# APPROVED MINUTES

## July 15, 2021 Standards Committee Meeting

RE: Minutes from the July 15, 2021 Standards Committee Meeting

STANDARD SPECIFICATIONS, SPECIAL PROVISIONS AND STANDARD DRAWINGS  
REVISION TO STANDARD SPECIFICATIONS, RECURRING PLAN DETAILS (RPD), AND STANDARD DRAWINGS

**STANDARD DRAWING NO. E 802-SBTS-10 1 2**

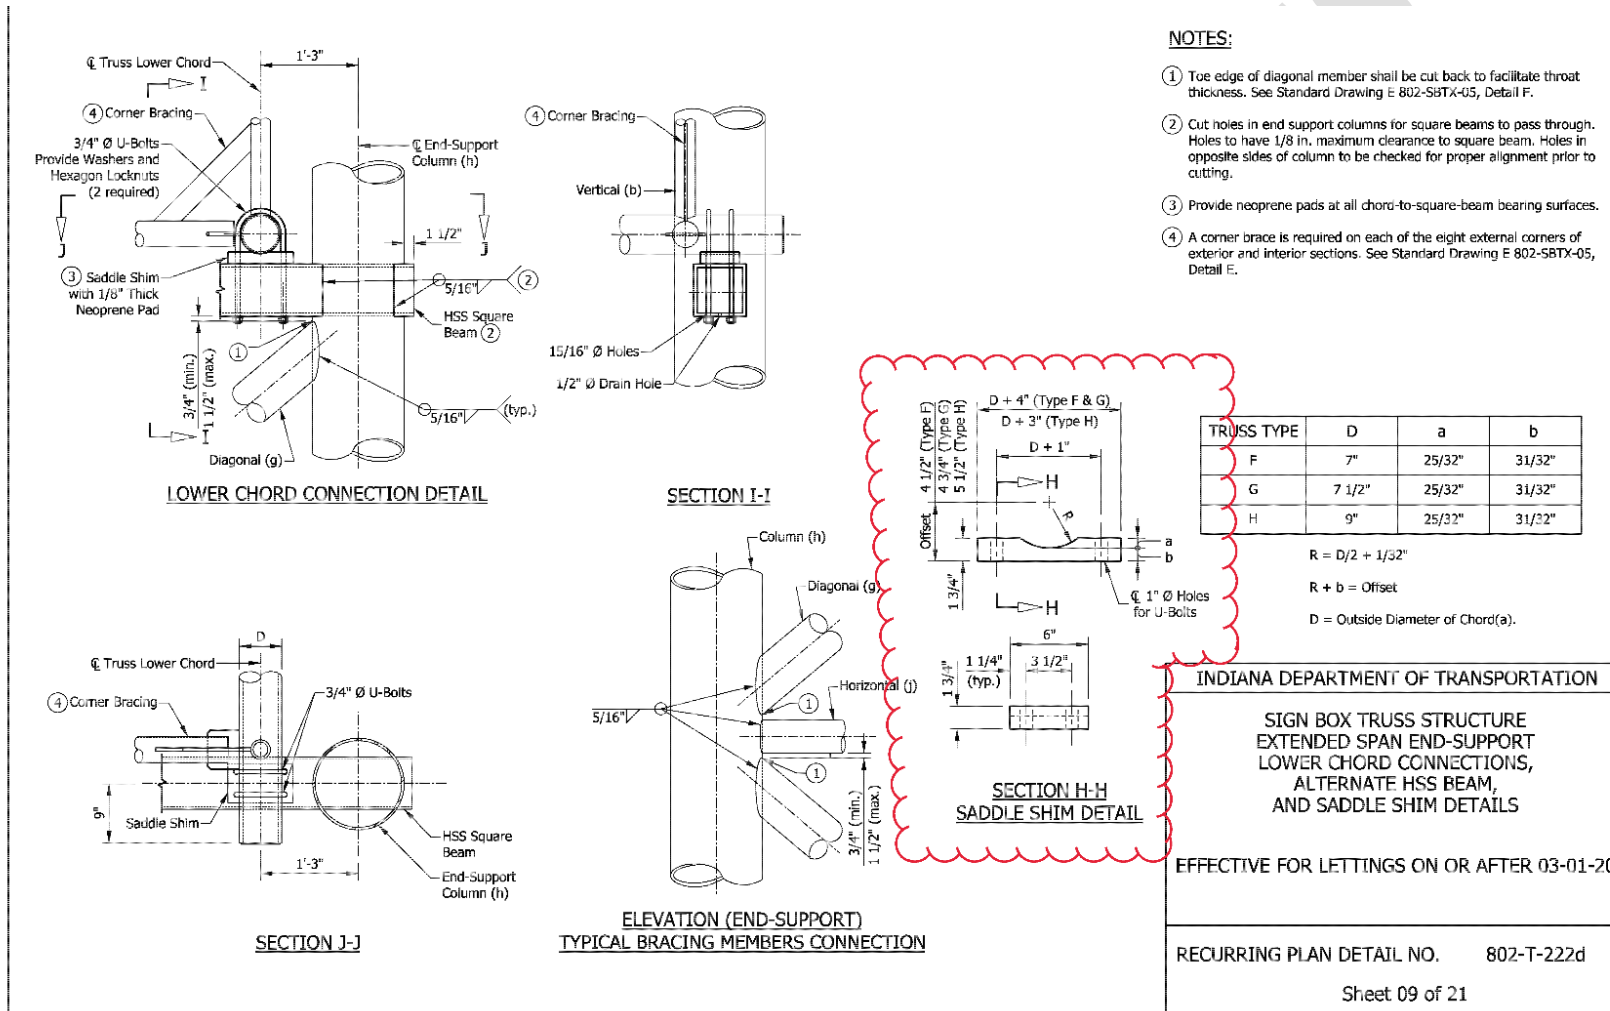
**ADDING SECTION HH SADDLE SHIM DETAIL (TYPES F-H) FROM RPD 09 OF 21**

STANDARD DRAWING NO. E 802-SBTS-13

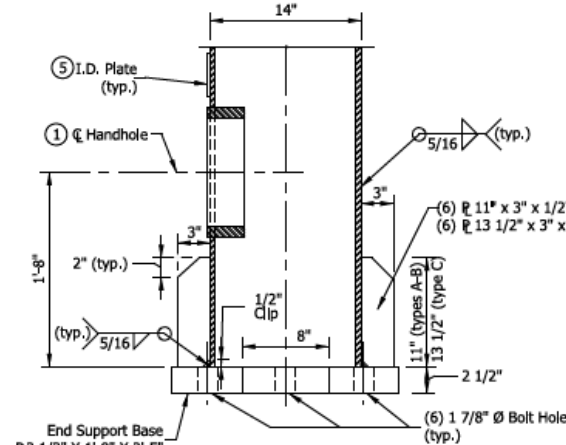
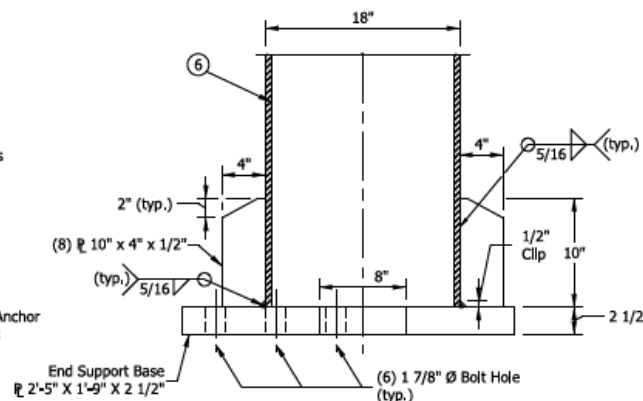
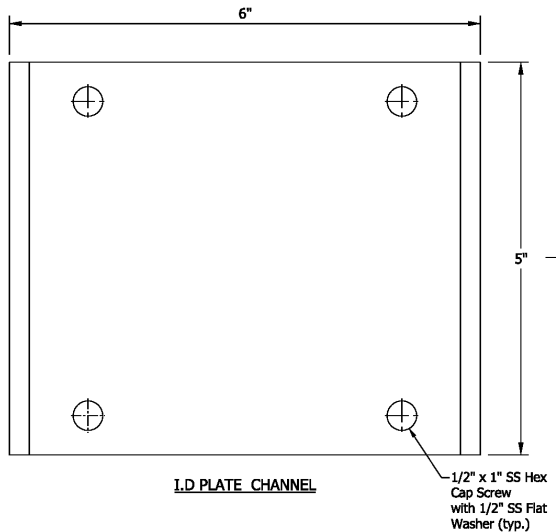
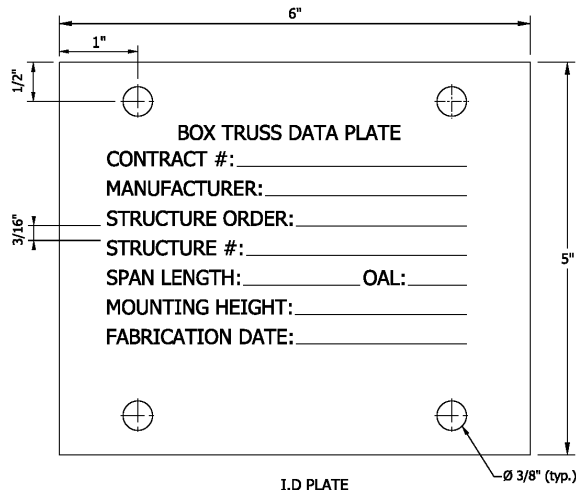
Also, additional detail on sheet 13 (revised draft shown in these minutes) is to provide for the crossing of the diagonal members in the end supports; the other changes are in formatting or are editorial per the Standards Office.

E 802-SBTS series (PROPOSED DRAFT -01 thru -41) Sheet 13 (revised draft)
